ISSUED ON: July 15, '96

Model	AD3	Volt/Hz	Date of Modification	Serial Number
Modified Article	Special Tools	No serial number cut-in information		
Reason for Modification	Parts catalog correction

Modification Bulletin

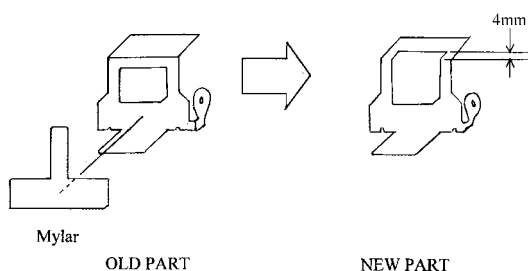
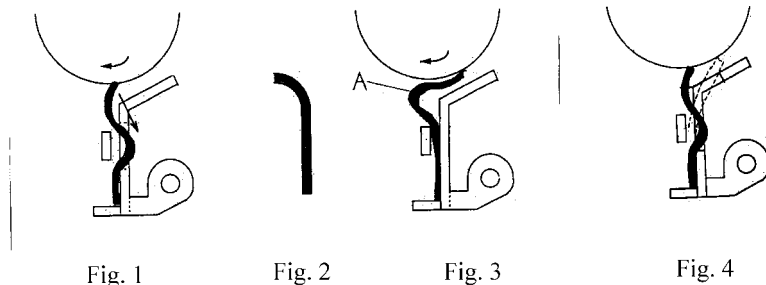
Mylar damage.

The mylar should move as shown in Figure 1, but after repeated use of the 50-sheet stack mode in the duplex unit, the mylar may curl as shown in Figure 2. If the mylar becomes deformed as shown in Figure 2, then its movement will resemble that shown in Figure 3. If this movement is repeated, then section A of the mylar will be damaged.

To prevent the mylar from curling, the shape of the bracket has been changed so that the mylar will bend as shown in Figure 4 below.

17. TONER BOTTLE SECTION (A133)

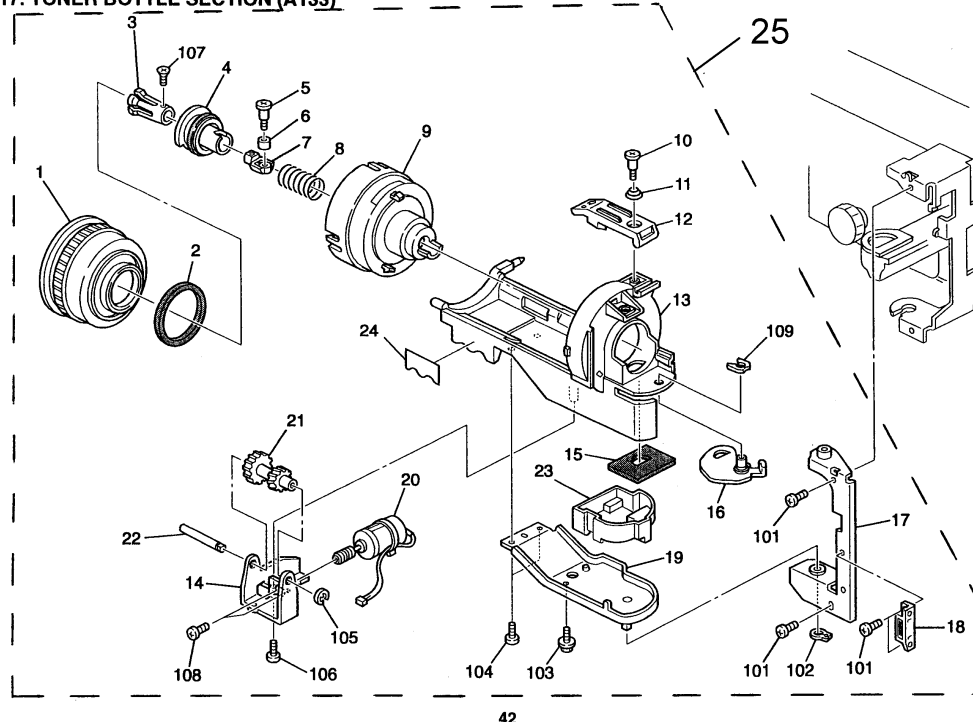
The following parts have been added as service parts.

Old part number	New part number	Description	Qty	Int	Page	Index	Note
	A1333150	Bottle Holder Assembly (RIC-115V)	1		43	25	
	A1333152	Bottle Holder Assembly (OEM)	1		43	33	
	A1343150	Bottle Holder Assembly (RIC-230V)	1		43	25	
	A1341384	Cap-Front Cover	1		11	33

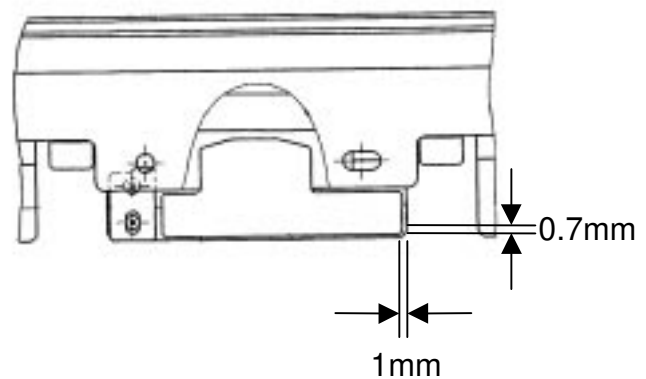
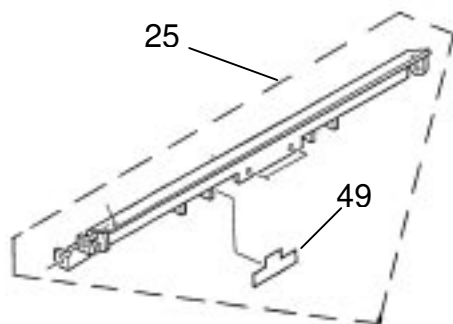
Please refer to the illustration below for the attachment position of the mylar.

Old part number	New part number	Description	Qty	Int	Page	Index	Note
	A1344670	Duplex Guide Mylar	1		63	49	New Index

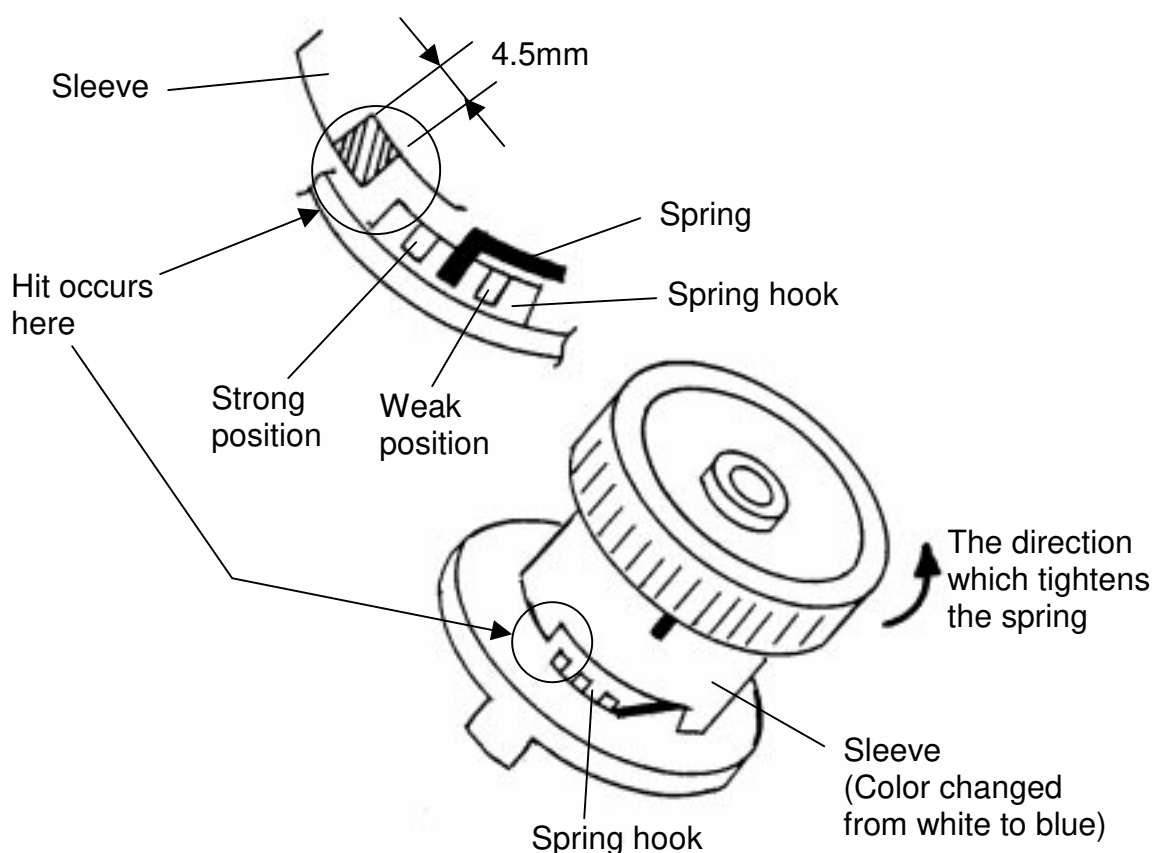
To reduce no-feed jams in the duplex unit caused by insufficient pressure from the bottom plate, the shape of the spring clutch has been changed. To distinguish between the old and new clutches, the color of the sleeve has been changed from white to blue.

To prevent the sleeve from hitting the spring hook, a 4.5-mm wide section of the sleeve has been cut away as shown.

Old part number	New part number	Description	Qty	Int	Page	Index	Note
AB040015	AB040017	Spring Clutch – Tray Bottom Plate	1	X/O	63	35

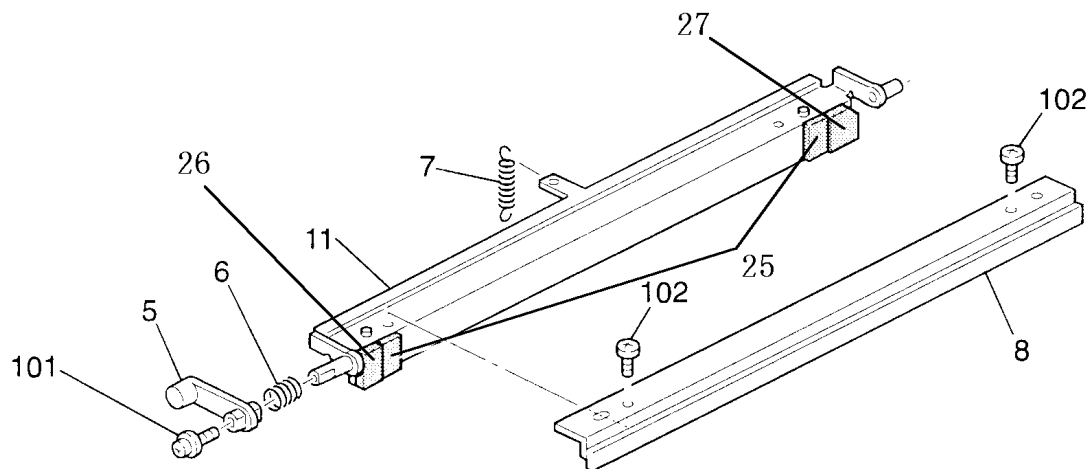
The following parts have been added as service parts.

Old part Number	New part Number	Description	Qty	Int	Page	Index	Note
	AA151809	Rear Seal	2		49	25	New Index
	AA151807	Shield:Blade:Front	1		49	26	New Index
	AA151782	Shield:Blade:Rear	1		49	27	New Index

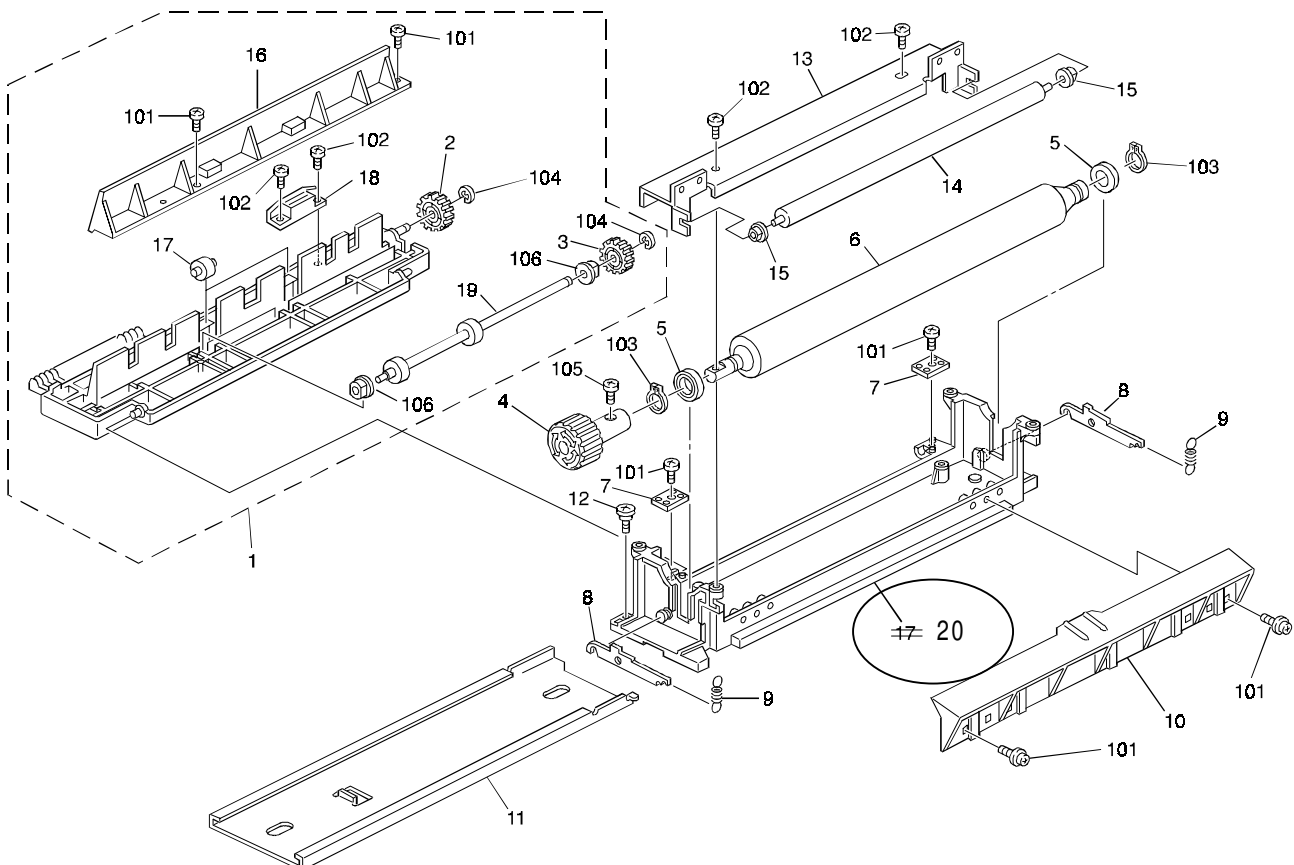
Old part number	New part number	Description	Qty	Int	Page	Index	Note
A1343164	A2173163	Bracket - Toner Holder	1		43	17	*1
	A1344151	Fusing Frame	1		57	20	*2

Note: (*1) Part number is corrected.

(*2) Index number of illustration is corrected.

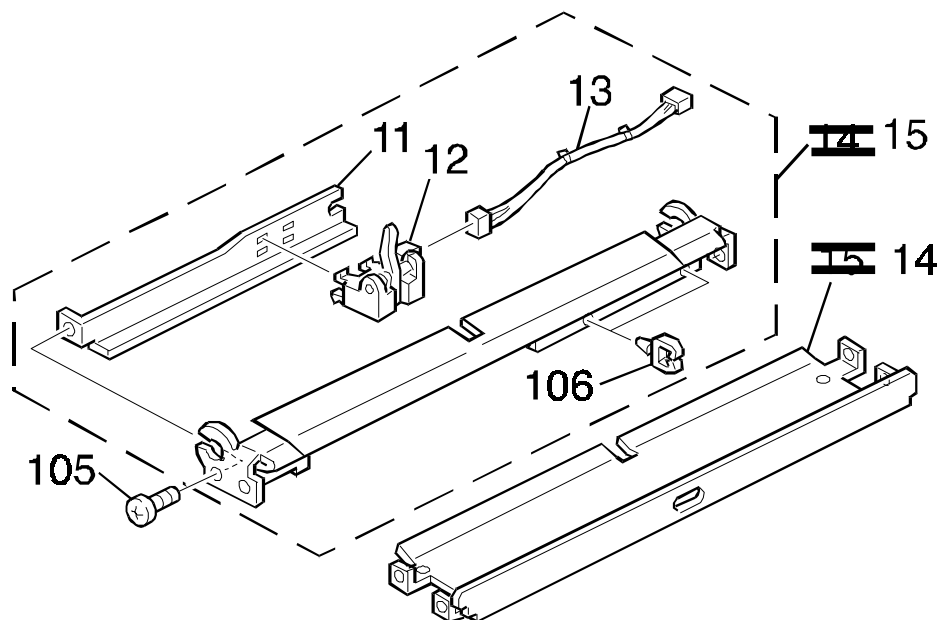
The following index number and part number should be corrected. Please correct your parts catalog.

Old part number	New part number	Description	Qty	Page	Old Index	New Index
A1342558	----	Upper Guide Plate - Registration		30	14	15
A1342553	A1342552	Lower Registration Guide		30	15	14

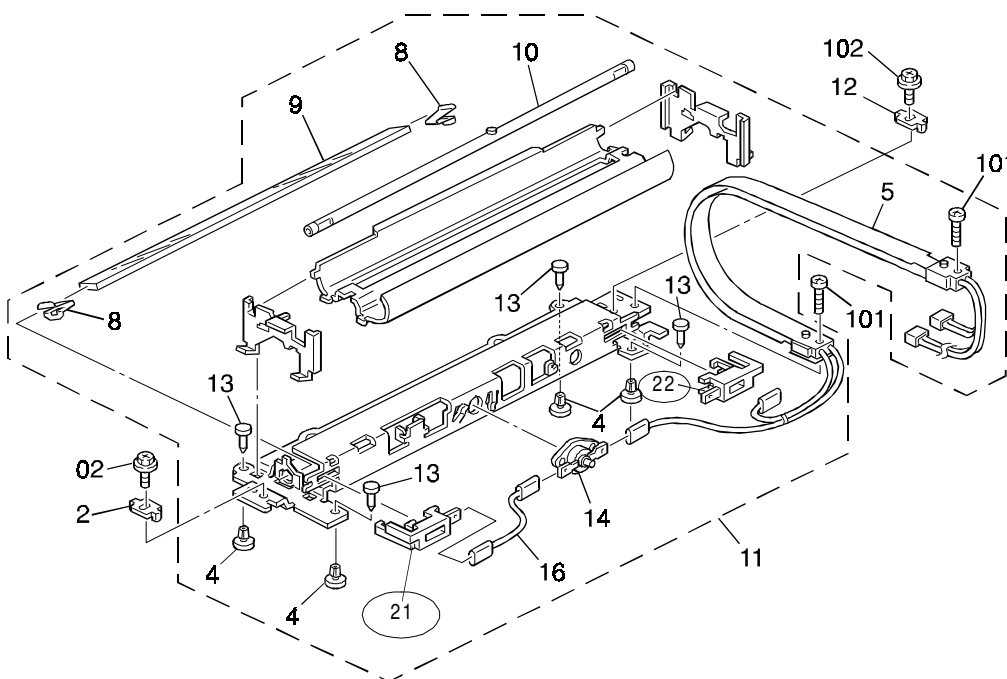
The following parts have been added. Please correct your parts catalog.

Old part number	New part number	Description	Qty	Int	Page	Index	Note
	A1341771	Front Terminal	1		33	21	
	A1341773	Rear Terminal	1		33	22

4. TRAY PAPER FEED (A133)

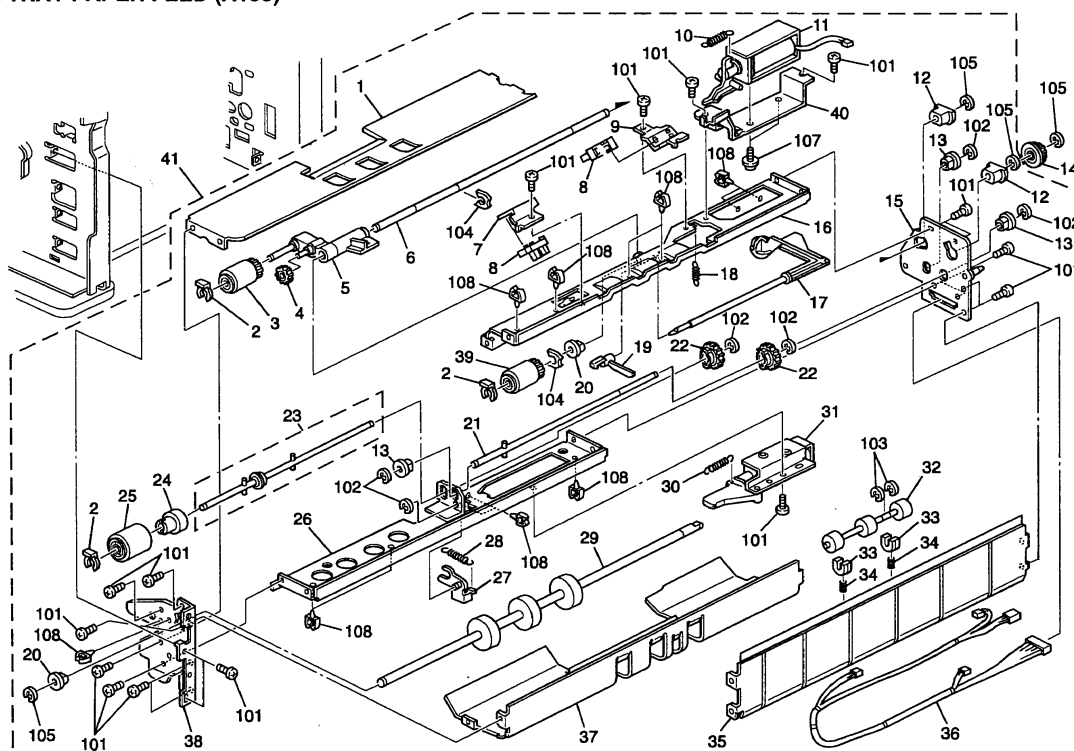
The following parts have been added. Please correct your parts catalog.

Old part number	New part number	Description	Q'ty	Int	Page	Index	Note
	A1342750	Paper Feed Unit – Lower	1		17	41

13. OPTICS SECTION 2 (A133)

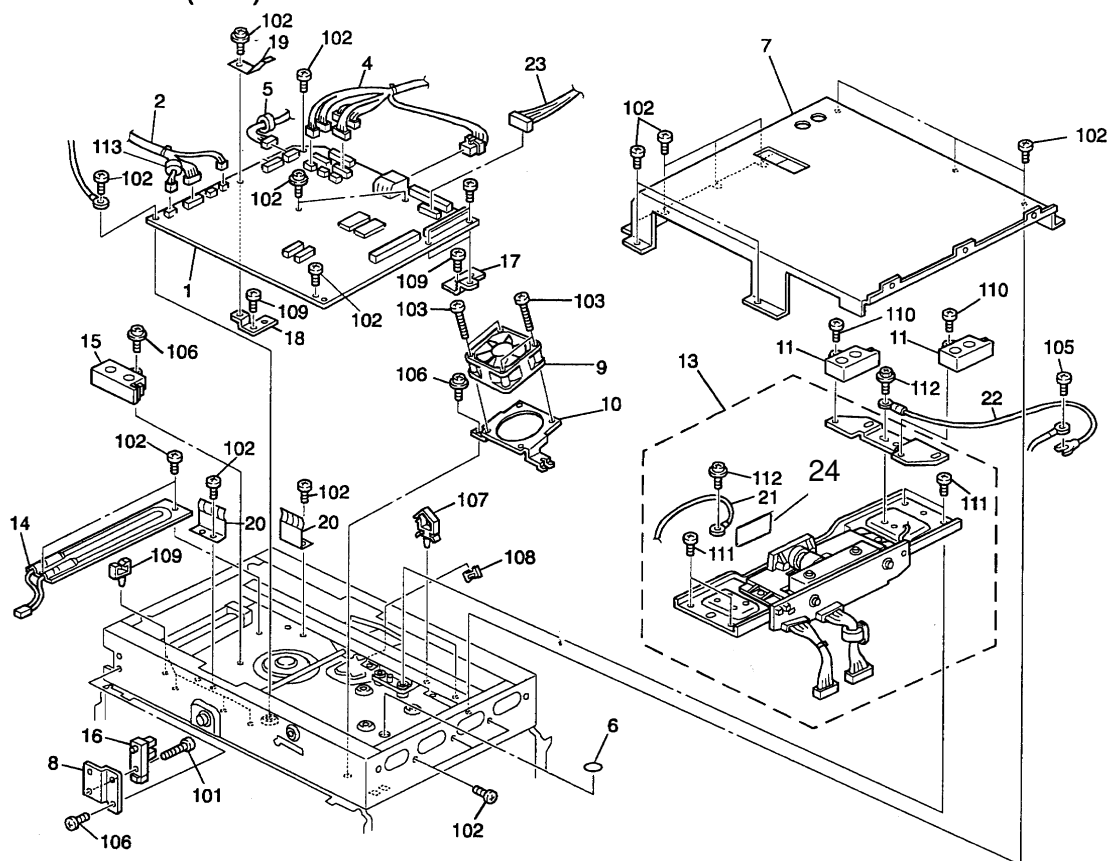
The following part has been added as a service part.
Please add this to your parts catalog.

Old part number	New part number	Description	Q'ty	Int	Page	Index	Note
-	AA011041	Light Filter-G530/G533	1	-	35	24
